Castlelake SHD,
Carrigtwohill, Co. Cork

Quality Audit

Document Ref:	P22-040-UQA-GEN-RP-001
----------------------	-------------------------------

3.4.1 Problem

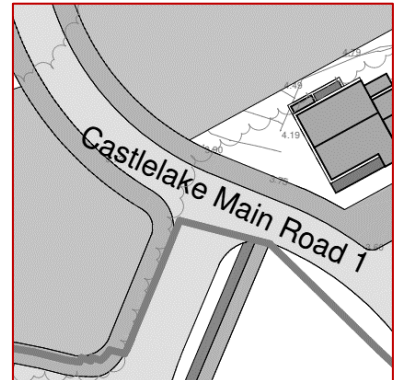
Summary: Junction control, or priority, has not been indicated at the junctions within the proposed development sites.

The junction control (stop, yield etc.), and thus priority, at the development's internal junctions has not been indicated. The absence of adequate road markings and signage may lead to driver confusion and hesitation resulting in drivers misinterpreting priority at the junction and entering the junction at the same time as opposing vehicles where there is an increased risk of side-swipe or side-on collisions.

Ensure the junction control, and priority, at internal junctions between residential streets and main roads, and at crossroads, is clear via signage and road markings.

3.4.4 Problem

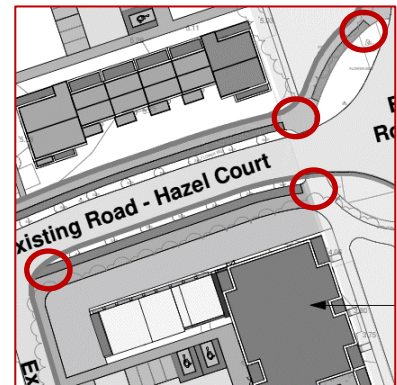
Summary: Tactile paving has not been indicated at the transitions between shared surfaces and segregated footways.

Tactile paving (e.g. ladder and tram) has not been indicated at the start and end of shared and segregated surfaces. This could lead to visually impaired pedestrians inadvertently entering the cycle track, or approaching shared surfaces and being unaware of the presence of cyclists, which may increase the risk of pedestrian-cyclist collisions.

Also, it is unclear how cyclists are to safely transition to the carriageway at the end of the cycle track. Drivers may be less attentive to a cyclist entering the carriageway from a raised cycle track resulting in an increased risk of vehicle-cyclist collisions.

Tactile paving (e.g. ladder and tram) at the interfaces between shared and segregated surfaces should be provided.

Measures should be provided upstream of a junction to safely guide cyclists into the traffic lane. These measures should also include guidance for drivers such that they will be aware of the potential for cyclists to enter the traffic lane, and clearly advise of the priority between cyclists and motorised vehicles at the transition.

3.4.5 Problem

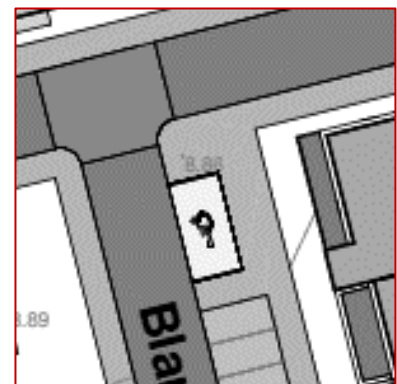
Summary: Absence of dropped kerbs and tactile paving at the mobility impaired parking spaces.

Mobility impaired parking spaces have been indicated throughout the development. It is unclear from the information provided if dropped kerbs and associated tactile paving are proposed at each Mobility impaired parking space. The absence of dropped kerbs could lead to difficulties for mobility impaired road users in accessing the footpath once they leave their vehicle, and force users to travel long distances within the carriageway until a dropped crossing is found, which may increase the risk of vehicle/pedestrian collisions.

Provide dropped kerbs & tactile paving at mobility impaired parking spaces to permit safe access to/from the footways.

3.4.6 Problem

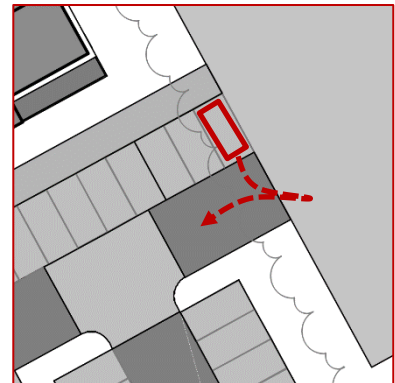
Summary: It is unclear if there is sufficient space for vehicles to safely exit all parking spaces within the development.

Drivers may be unable to safely exit parking spaces located at the extents of the carpark, where they are in areas constrained by adjacent parking spaces, building structures, or kerbs. The constrained nature of these parking spaces may lead to material damage collisions.

Swept path analysis should be undertaken within the internal carparks, and the layout adjusted where necessary.

3.4.7 Problem

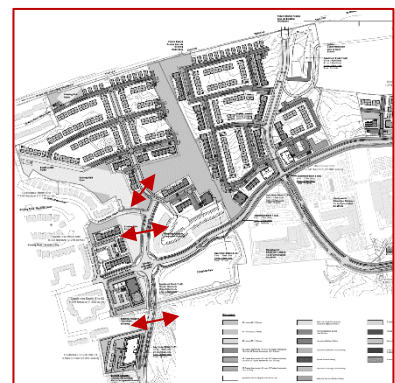
Summary: Unclear if there is sufficient space for vehicles to safely perform a u-turn manoeuvre when exiting the internal street.

Mobility impaired parking spaces are located at the end of Blandcrest Street 01 and Station Road Street 03. Given the local constraints at each parking space, users within the Mobility impaired parking spaces may be required to reverse long distances to exit the street. This may increase the risk of material damage and vehicle/pedestrian collisions.

The mobility impaired parking spaces should be reoriented to provide safe access and egress.

3.4.8 Problem

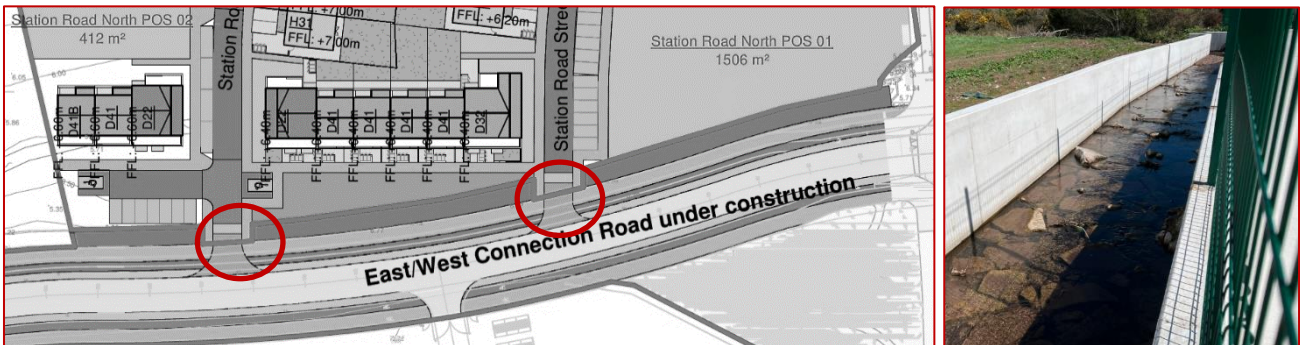
Summary: Failure to provide VRU facilities on all pedestrian desire lines may lead to slips, trips, and falls.

The development proposes uncontrolled pedestrian crossing points (i.e. tactile paving) in certain locations, but not all pedestrian desire lines have been accommodated within the scheme extents. No facilities have been provided between the existing public open space and the surrounding residential developments, for example across Castlelake Avenue or Castlelake Main Road. Failure to provide an appropriate facility for non-motorised users at these expected desire line could result in unsafe

crossings of the carriageway, leading to slips, trips, and falls.

A thorough review of likely pedestrian desire lines should be undertaken, and tactile paving/dropped kerbs provided to facilitate safe VRU movement.

3.4.11 Problem

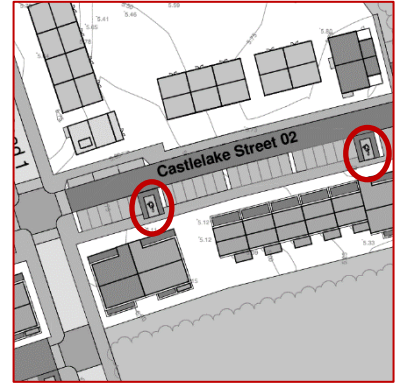
Summary: Inset mobility impaired parking spaces reduce the effective width of the footway.

Inset mobility impaired parking spaces are indicated at several locations within the development. These inset spaces reduce the effective width of the footway, and may force opposing pedestrians to step into the parking space, which may increase the risk of vehicle/pedestrian collisions.

Ensure the effective width of the footpaths within the development are sufficient to accommodate the expected volume of pedestrians (in both directions) during peak times, particularly wheelchair users and parents with buggies.

3.4.12 Problem

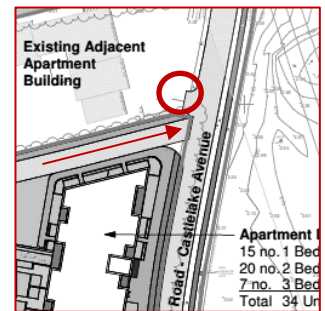
Summary: The Apartment block 1 development access is in close proximity to an adjacent apartment block access onto Castlelake Avenue.

The development access for Apartment Block 1 is proposed in the northeast corner of the site. However, the proposed access is in close proximity to an existing development access to the north of the site. Proximity of the accesses could result in complicated interactions between the two accesses, driver uncertainty and confusion, as well as vehicles in adjacent accesses blocking each other's visibility. This may lead to side-on, material damage and personal injury collisions.

The proposed development access to/from the Castlelake Avenue should be relocated, ensuring visibility requirements are met at the revised access.

4.2.1 Issue

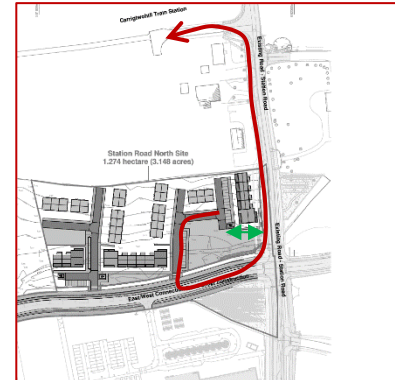
Unclear if there will be a pedestrian/cycle link provided between Station Road North Site and Station Road.

The Carrigtwohill Train Station is likely to be an attractive destination for commuting residents of the new apartment block at the Station North site. However, there are currently no direct pedestrian links between the development and Station Road. As a result, pedestrians will be forced to travel a circuitous route to gain access to Station Road. This may discourage some residents from using the train station.

Provide a pedestrian link between Station North and Station Road.

5.1.1 Issue

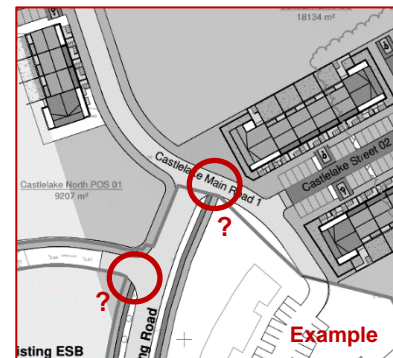
Pedestrian and cycle improvements are currently proposed on Station Road. These proposals are being developed by Cork County Council, and are not subject to this audit. At the time of this audit, the proposals for Station Road were not known, and the programme for implementing these proposals was not clear. If the new link roads are opened to the public prior to the implementation of Station Road's pedestrian and cycle improvements, the Audit Team is concerned that the lack of cycle connectivity between Station Road and the newly constructed links roads will discourage users from cycling to the station.

The two accesses on Station Road should not be opened to the public until the Station Road improvements have been completed.
